**Fan motor failure after a longer operating time****Models:       Refrigerators and Freezers with fan blade 6299 905-02**

Fig. 1.0: Art.No. 6299 905-02

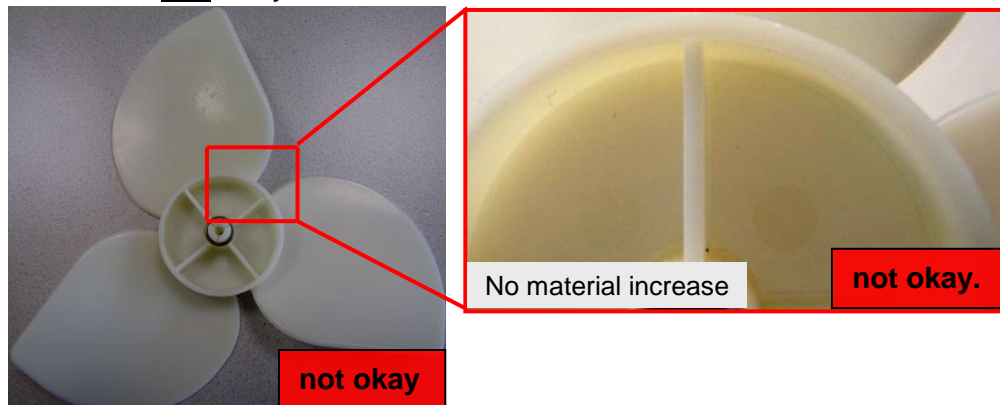
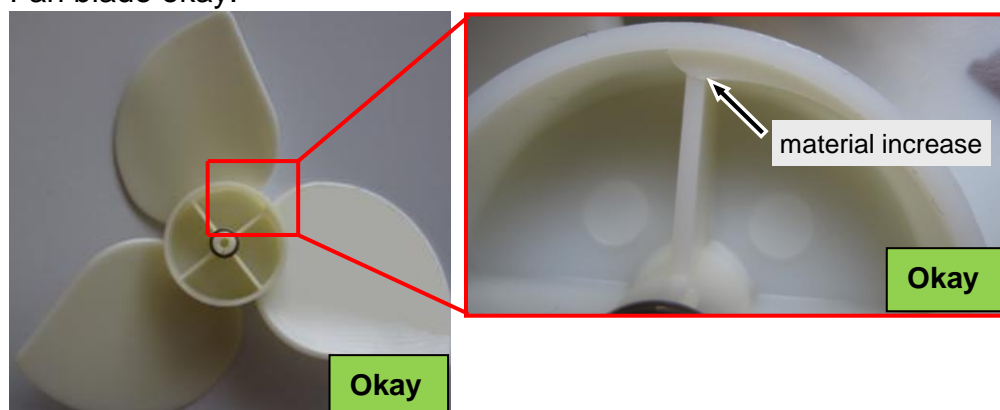
**Cause:** The defect of the fan motor (e.g. bracket defect) can be effected by an imbalanced fan blade.

Fan blade **not** okay:

Fan blade okay:

If there is no material increase obviously (like in Fig. 1.0), change the fan blade to the new one.

**To correct:** Check the fan blade in addition to the replacement of the fan motor.  
(See next page)

Spare part	Until now	<b>NEW</b>
Fan blade	6299 905-02	<b>6299 905-03</b>

**Note:** Previous fan blade must not be used anymore.
